INSPECTION REPORT  
Sedimentation Structure  
N1-L  
Kayenta Mine  
Navajo County, Arizona  
for  
PEABODY COAL COMPANY

Dames & Moore  
10139-011-22

EXISTING  
MAXIMUM CROSS-SECTION  
A-A'  
N1-L

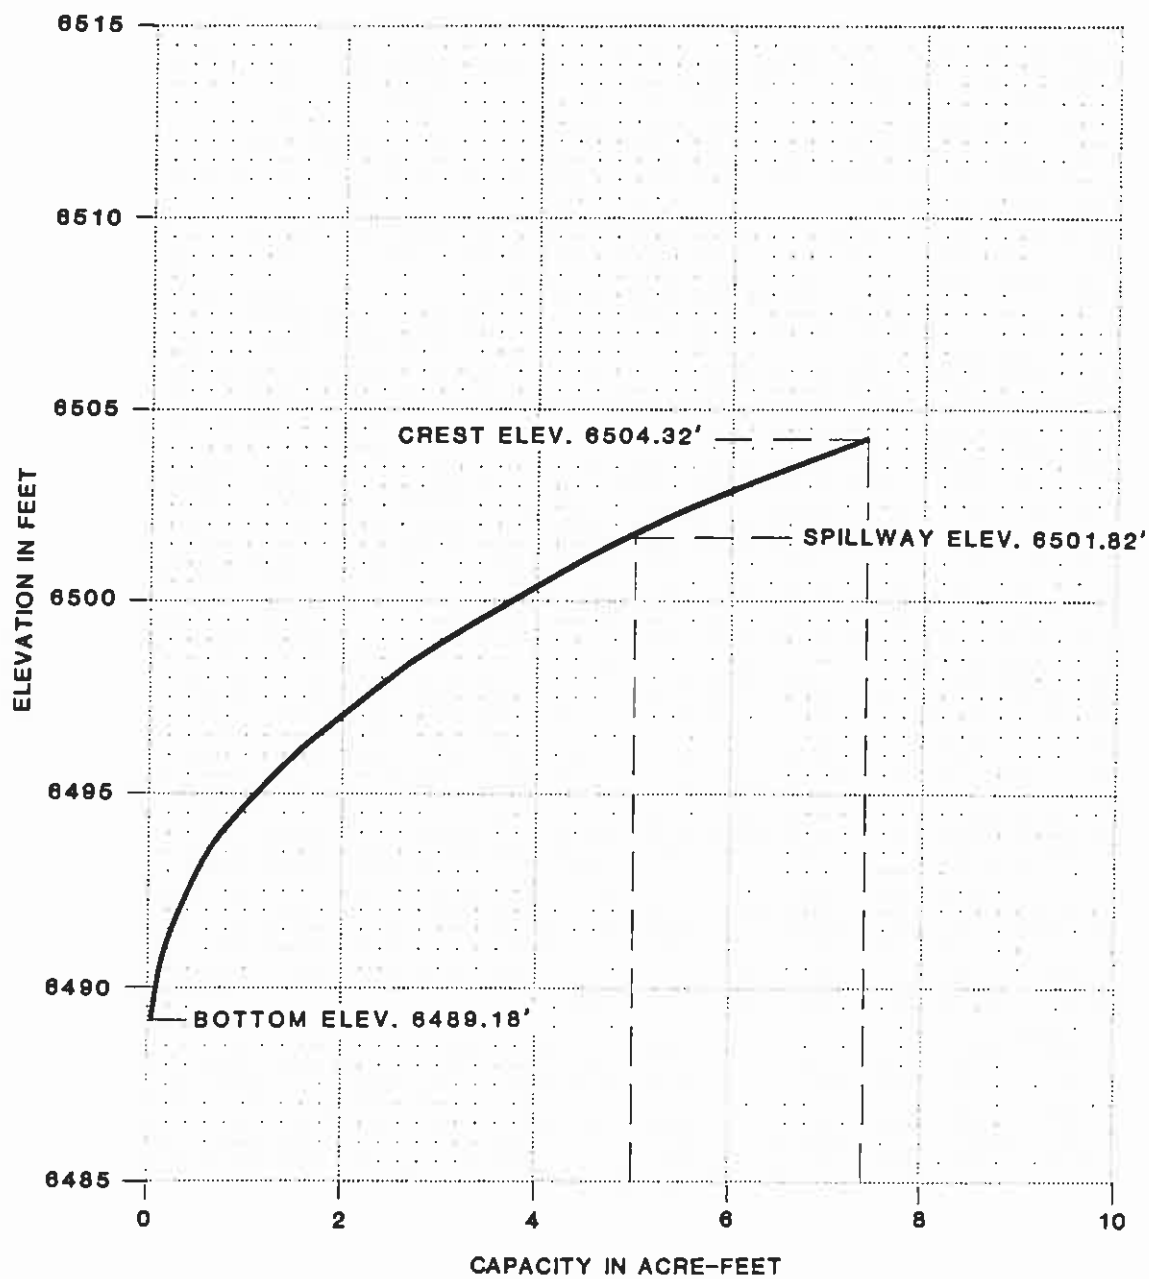
The N1-L embankment is lower in height; however, the downstream slope is steeper than the category standard; therefore, the embankment has factors of safety less than the design minimum.

The inspection of Structure N1-L indicated that the only geotechnical problem is rill and gully erosion on the upstream and downstream slopes, the side slopes of the approach and spillway channel; and the bottom of approach channel. The downstream slope should be flattened to 4.0 horizontal to 1 vertical to meet stability requirements. Correction of erosion is considered a periodic maintenance task and does not require remedial action.

CHANNEL PROFILE B-B'  
N1-L

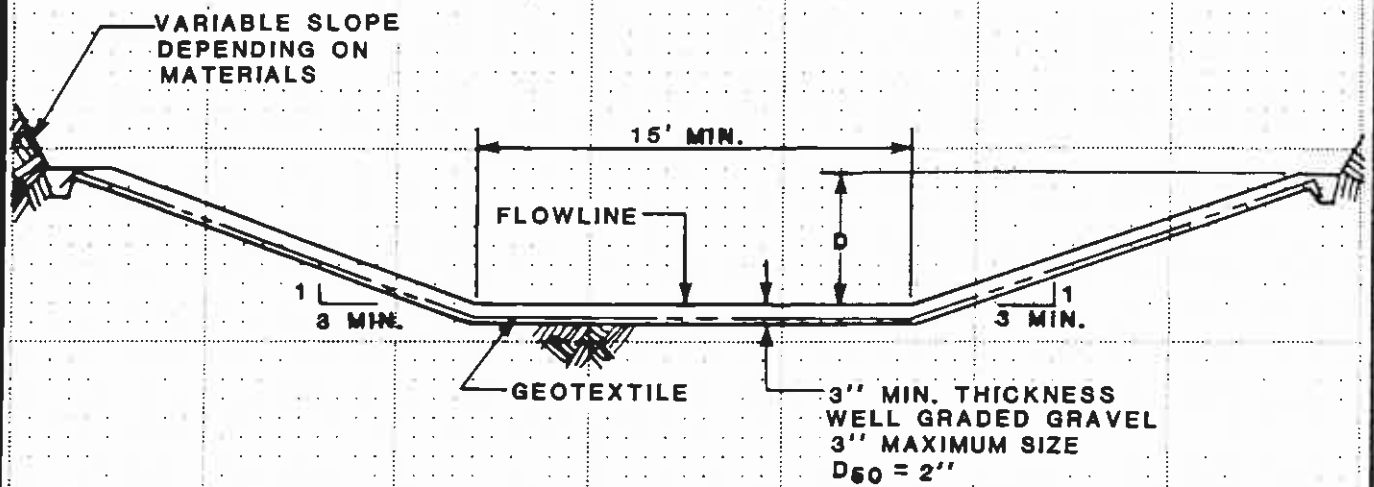
The storage capacity and spillway capacity of Structure N1-L are adequate; however, the spillway does not have an outflow channel or adequate erosion protection. A trapezoidal outflow channel should be constructed along the alignment B-B' shown in Plate 1. The channel profile is shown in Plate 4 and the required dimensions are shown in Plate 5. Both the spillway and outflow channel should be protected against erosion using geotextile and gravel as shown in Plate 5.
